GLASTAR SERVICE BULLETIN 40

Subject: Elimination of trim tab counterweight with electric trim system

Applicability: All GlaStar kits shipped prior to the publication of *Assembly Manual* Revision D **and** equipped with electric elevator trim

Figure 1: Dimensions for New-Style Trim Tab Control Horn

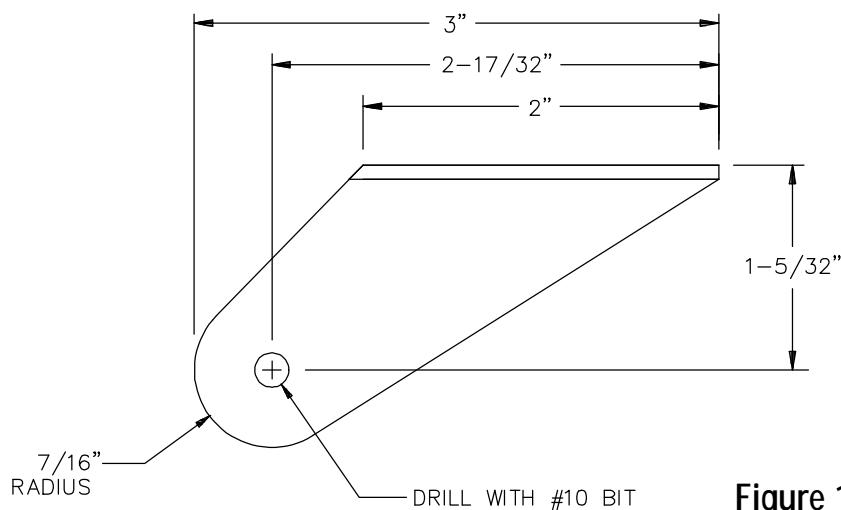
If you elect to remove the counterweight arm but retain the original control horn, you have the further choice of leaving the horn as is or trimming it to match the current shape, as shown in Figure 1.

If you wish to replace the trim tab control horn, order **3-1/2"** of **.050" X 1-1/4" X 1-1/2" aluminum tee extrusion** (P/N 100-0640-007) and fabricate a new control horn to the dimensions shown in Figure 1 on the following page. Drill out the old control horn rivets, and use a hole duplicator to drill matching holes in the attach flange of the

For GlaStars on which the trim tab counterweight has not yet been installed, it is recommended that the trim tab control horn be fabricated to the dimensions shown in Figure 1 and that the trim tab counterweight arm and counterweight be omitted. Concretely, that means the following:

- A) Substitute Figure 1 below for Panels A and B of Figure 39.1 in "SECTION V: ELEVATOR ASSEMBLY."
- B) Disregard the last paragraph of Step 61 in "SECTION V: ELEVATOR ASSEMBLY."
- C) Disregard the following figures and steps in "SECTION V: ELEVATOR ASSEMBLY": Figures 39.2, 46 and 50; and Steps 67 and 77.
- D) Disregard the following figures and steps in "SECTION X: FINAL ASSEMBLY": Figures 181–183; and Steps 166 and 167.
